pd-trigger — Design Document

ai-ee v1 pipeline

Board review (P8 adversarial) - pd-trigger

5 Schematic

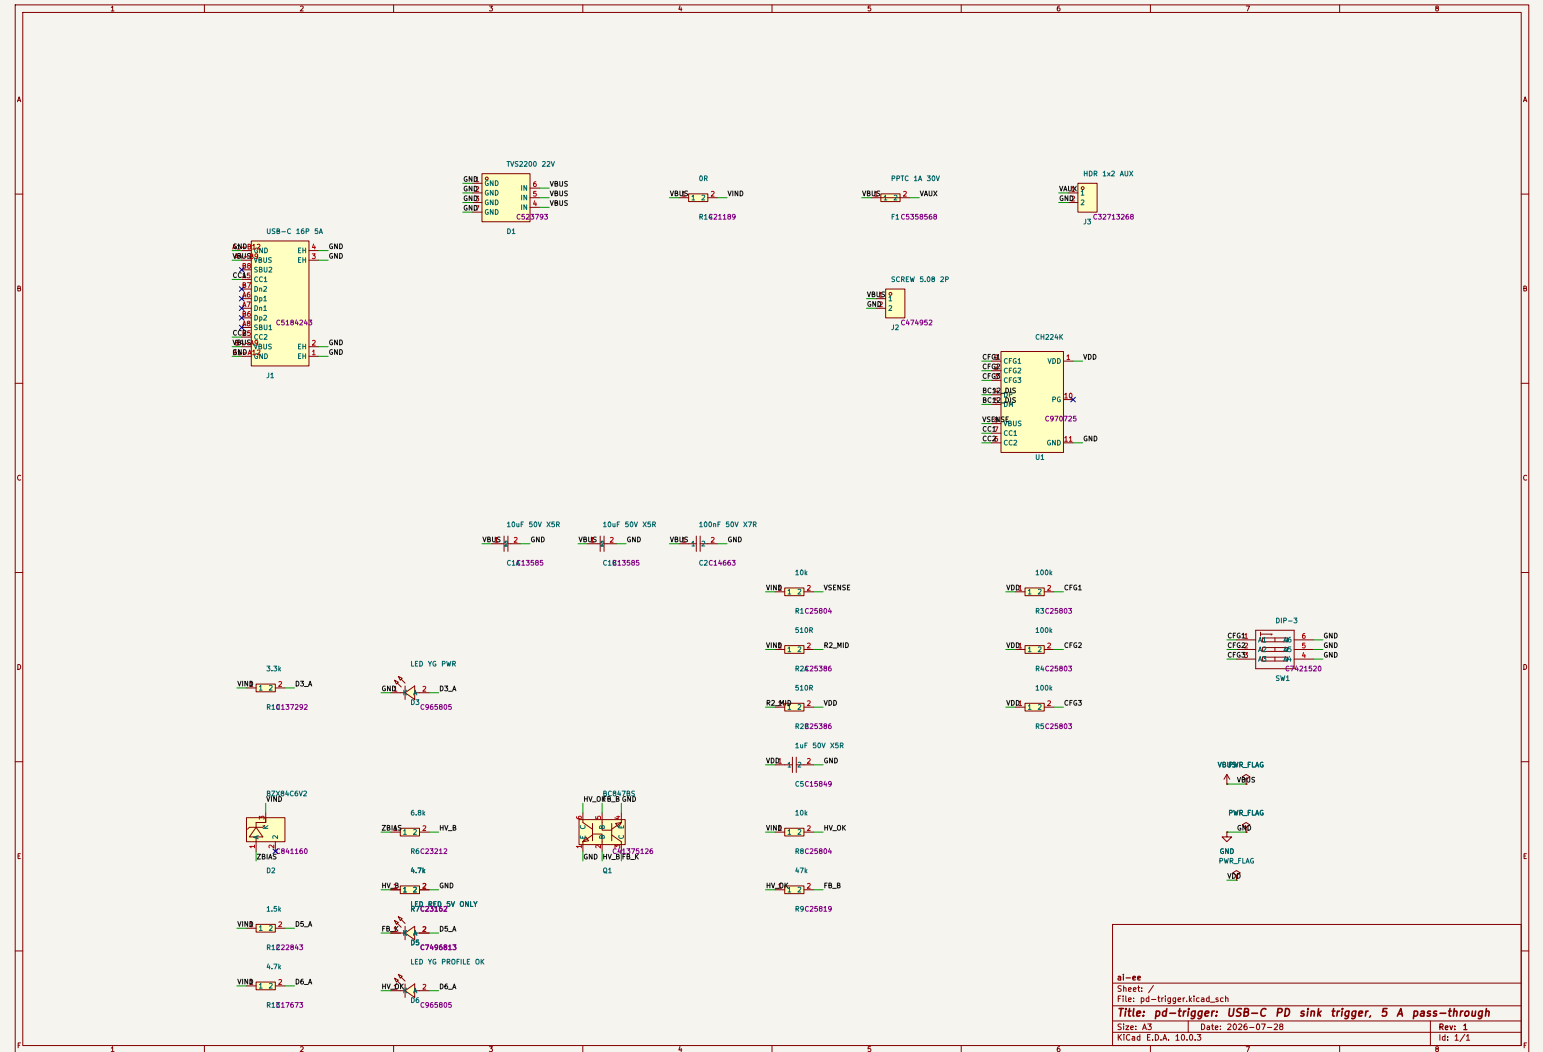
W1 dp-dm-short-at-chip: architecture’s PD-only short (`/BC12.DIS`) ACCEPTED by the reviewer as hardware-SAFER than the datasheet’s connector wiring (removes a 21V-onto-3.8V-abs-max fault path). Cost: no QC/BC legacy support - the board is “PD sources only”; goes on B.SilkS + order docs. W2 vdd-worst-corner: true worst case 0.979mA at 4.4V low-line all-straps- closed vs unpublished CH224K IDD - bounded by WCH’s own reference circuit; V1 bring-up step: measure VDD at the 5V profile; contingency = both 510R -> smaller (documented floor 600R total). Bring-up addenda: buzz out Q1 E/B/C once (clone PDF JS-gated; Nexperia- standard pinning verified as the compatibility claim).

reports/render_final/top.png

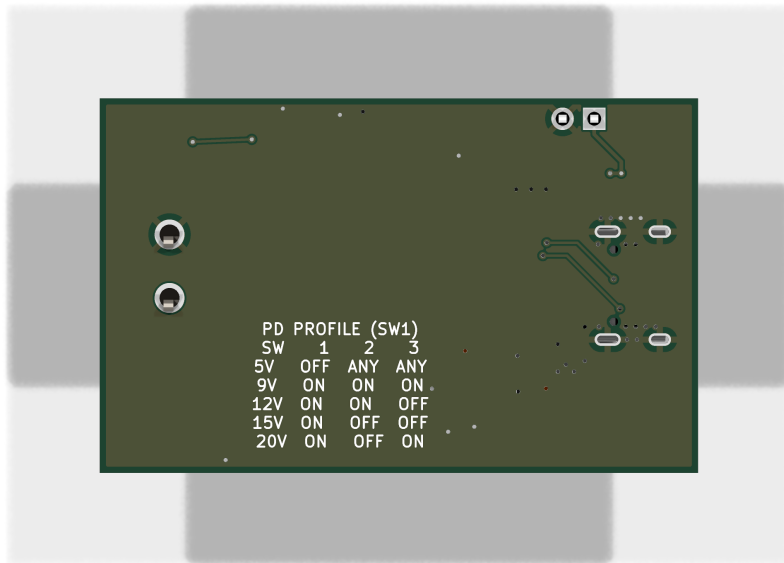
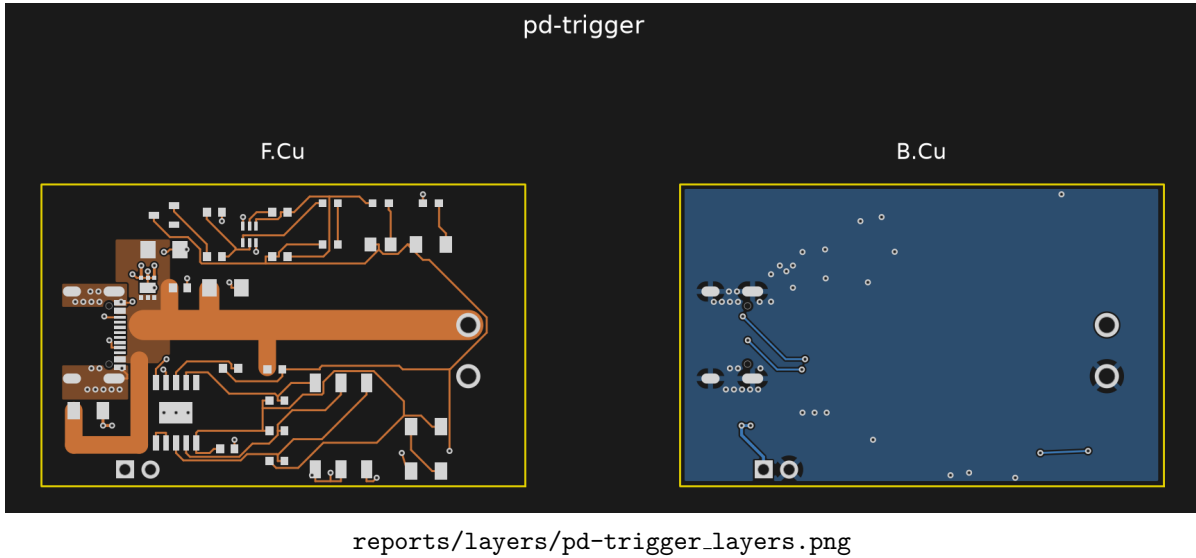
E1 - 5 A return chokes at J1's GND contact pads (error, checker-blind by design D7)

The 4 GND cable contacts land on two merged SMD pads (F.Cu only): A1-B12 at (17.63,39.31) and B1-A12 at (17.63,45.71), nominally 2.5 A each at the 5 A rating. Their ONLY copper into the B.Cu return pour:

- A1-B12 (top): a 0.2 mm wide, 2.7 mm long F.Cu chain (3 segments) into shell pad 1's THT barrel, plus one 0.6/0.3 via whose annulus grazes the pad corner by ~0.05 mm (etch-tolerance-level). 0.2 mm at 2 oz = 0.80 A capacity at 10 C rise (pipeline model); at 2.5 A the same model gives ~133 C rise (short-neck heatsinking will moderate this, but it is a >3x overcurrent on the model's own terms). ~13.6 squares = 3.3 mohm.
- B1-A12 (bottom): a 0.2 mm x 1.3 mm trace into ONE 0.6/0.3 via. The board's own via budget (constraints via_amps 0.5) says 2.5 A needs 5 vias; there is 1. Shell pad 4 sits 0.32 mm away but is NOT connected on F.Cu - its copper does not help.

Architecture D7/power_tree structural requirement ">= 10 vias at J1's GND pads" (the stated substitute for keeping GND out of power[] so check_current stays quiet): not delivered. DRC cannot see it (0.2 mm is netclass-legal), check_current cannot see it (GND undeclared), check_return_path no-ops (no high_speed key). Failure mode: sustained 5 A at any profile heats the two necks far past the 10 C design intent; long-term trace/joint fatigue, intermittent ground, and full return current cascading onto the surviving 0.2 mm chain. Fix is cheap at P9: an F.Cu GND spandrel bonding each contact pad to its shell pad (the VBUS pour top edge is at y 39.7 - the strip above it, and the strip x < 17.2 plus the region south of y 46, are free) plus 4-5 vias per side.

E2 - Safety/waiver silk markings absent (error, promised artifact) Board-wide gr.text count is ZERO; B.SilkS carries nothing at all (both B.SilkS references in the file are the stackup layer table). Missing, each one a written promise:

- AUX 1A MAX + V+/GND at J3 (P0 answer 4 "silk-marked", V10). F1 makes overload safe-by-hardware, but polarity of the 2-pin aux header is unmarked.
- PD SOURCES ONLY (ERC waiver W1's standing condition: "goes on B.SilkS + order docs"). The waiver's silk half is currently unfulfilled.
- J2 screw-terminal polarity. Trunk lands on J2 pad 1 = the LOWER screw (board-bottom side); nothing anywhere tells the bench user which screw is V+. Reverse-wiring a load on a 100 W output is the single easiest field mistake this board can cause.

E3 - User-interface silk absent (error, promised artifact)

- The five-row profile table on B.SilkS - D3 calls silk "the user interface" and specifies the table verbatim; the bottom is a clean pour with room. Without it the ON/OFF-to-voltage map exists only off-board; a user WILL set 9 V expecting 12 V by trial and error. (Fail-safe floor: any wrong guess >= the 5 V fallback, and OFF-fail = 5 V - the mistake is bounded but real.)

- LED legends PWR / 5V ONLY / PROFILE OK (D4/V10): the render shows refdes D3/D5/D6 only. The entire P0-answer-6 "visible fallback indication" scheme is mute without the words - a lit red LED labeled "D5" indicates nothing.

- Cable disclaimer "20V @ 5A needs a 5A e-marked cable and a 100W source" (V10 lists it as silk; power_tree s7 allows documentation - at minimum it must reach the order docs at P9/P10, which do not exist yet; fab/ is empty).

W1 - J1 mouth recessed ~0.4-0.5 mm behind the board edge (warning, flagged at P6)
Courtyard/silk front edge $x = 10.18$ vs board edge $x = 9.8$. USB-C receptacles are normally flush-to-overhanging; a recessed mouth lets thick/molded plug overmolds butt the board edge and hold the plug fractionally short of latch - intermittent CC, no PD, "works with some cables". On a bare bench board with arbitrary cables this is a real annoyance risk. Fix: nudge J1 -x 0.5-1.0 mm at P9 (pour edge follows; nothing else in that corridor), or accept and note in order docs.

W2 - Outline 48 x 30 mm exceeds the architecture's hard ceiling (warning, drift)
Edge.Cuts = (9.8,27.51)-(57.8,57.51) = 48 x 30 mm. D9: nominal 45 x 25, "hard ceiling 48 x 28 mm"; 30 mm violates D9's own ceiling by 2 mm even though it equals P0 answer 5's literal +20 % (40x25 -> 48x30, +44 % area vs the brief's target). No digest discloses the growth past D9. Consequence is cost/footprint only, but it must be disclosed to the user at the checkpoint rather than discovered.

A1 - J2 GND pad ties to the return pour through 4 thermal spokes (advisory) J2 pad 2 (THT, 2.4 mm pad / 1.6 mm drill) connects via 4 x 0.5 mm diagonal spokes = 2.0 mm total at 2 oz -> model 8 C rise at 5 A. Legal and functional, but these are the most-loaded copper necks on the whole return after E1, at a hand-soldered joint. Recommend a solid-connect override (or a short fat GND strap) at P9; zero cost. (Verified all 4 spokes present; the VBUS pad 1 island below it is barrel-tied, normal.)

A2 - F1's VBUS feed branch is 18.3 mm long (advisory, V8 letter-violation) V8/D8 wanted all five VBUS taps hugging the run with 2-3 mm stubs. D1, C1A, C1B, C2, R14 comply; F1's feed runs 8.4 + 6.5 + 3.4 mm at 1.75 mm width to the top-left corner. Width-compliant (V8's actual purpose), carries ≤ 1 A in service; only cost is ~30 mm² of extra always-live 20 V copper. No action needed; recorded as drift.

A3 - Floating 0.65 mm² GND sliver at (20.0, 28.5) (advisory, cleanup) plane_repair's own dead-island fact (0 anchors), between J3/SW1 clearances. Cosmetic / minor DFM nit; remove at P9 cleanup or accept.

A4 - /VAUX at PPTC max-non-trip current (advisory) /VAUX routes at 0.3 mm (required 0.25 at the declared 1.0 A -> 7 C). F1's worst sustained NON-trip current is ~1.8 A -> model 27 C rise on those runs until/unless the PPTC trips. Bounded, no damage threshold approached (70-80 C copper on a 20 V node); acceptable. Recorded so nobody "fixes" it blind later.

P8 digest (pd-trigger)
verify PASS 8/8 first try. Fable reviewer: 4 err + 2 warn. Copper errors
REAL: 5A RETURN choked at J1 GND pads (0.2mm necks/0.80A, 1 via) - rebuilt
w/ priority-1 F.Cu GND lobes (connect_pads solid) + 15 new 0.6/0.3 vias ->
5.68A/4.70A per pad, 16 vias (D7 >=10 met). Removed 2 stitch vias 0.121mm
from THT drills - LIVE-PROVEN KiCad DRC blind spot (via-drill vs same-net
pad-drill never checked, finding 34). Silk errors: 17 texts added; agent
CORRECTED the orchestrator's B-table spec (raw CFG bits would be inverted

vs ON=GND switch reality - printed switch positions). Warns: mouth recess
-> order docs; outline 48x30 deviation recorded; C1B channels waived w/
numbers. Re-gates: drc_routed 0/0, verify 8/8. H4 AUTO-approved.
